Planning Sub Committee - Monday, 11th December, 2023

ADDENDUM REPORT FOR ITEMS

<b>Reference No:</b> HGY/2023/2137	<b>Ward:</b> Northumberland Park
<p><b>Address:</b> Tottenham Hotspur Stadium, 748 High Road, Tottenham, London N17 0AL</p> <p><b>Proposal:</b> Minor Material Amendments to height, design, maximum floorspace and associated works to Plot 3 (Hotel / Residential development) of the hybrid planning permission HGY/2015/3000 (following previously approved amendments including HGY/2017/1183 to allow part residential (C3) use on Plot 3) for demolition and comprehensive redevelopment of the Northumberland Park Development Project through variation of Conditions A4 (Consented Drawings and Documents); A6 (Conformity with Environmental Statement) and Condition A7 (Maximum Quantity/Density) and D1 (Plot 3 specific drawings) under Section 73 of the Town and Country Planning Act (EIA development)</p> <p><b>Applicant:</b> THFC</p> <p><b>Ownership:</b> Private</p>

<b>Reference No:</b> HGY/2023/2306 & 2307	<b>Ward:</b> Bruce Castle (Northumberland Park opposite)
<p><b>Address:</b> 'Printworks' 819-829 High Road, Tottenham, London, N17 8ER</p> <p><b>Proposal:</b> Full planning applicat

Figure 7—4 Proposed location for future DEN connection into the Application Site

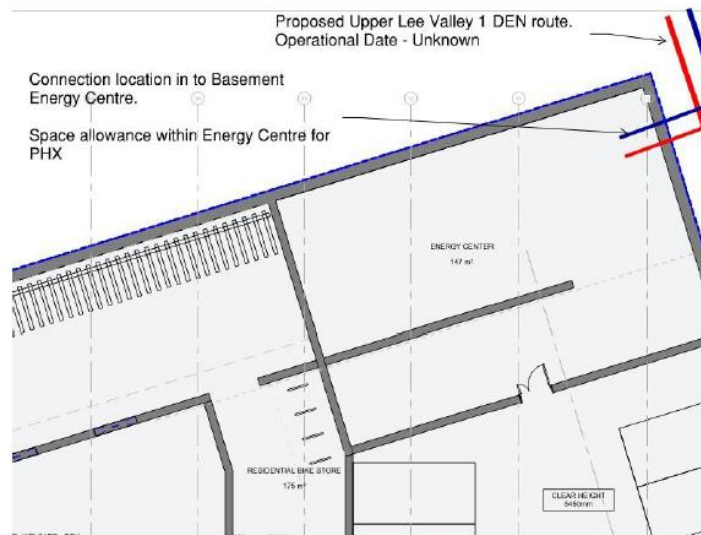
The Be Clean strategy to connect to the DEN in North Tottenham is generally acceptable. A site-wide carbon reduction of 32% is calculated under Be Clean, which is supported. Some evidence should be provided that the plant room is adequately sized for a substation.

The applicant will need to demonstrate that they will provide the following details prior to the commencement of construction:

- e) Buried pipe (dry and filled with nitrogen) to our specification from the GF plant room to a manhole at the boundary of their site and evidence of any
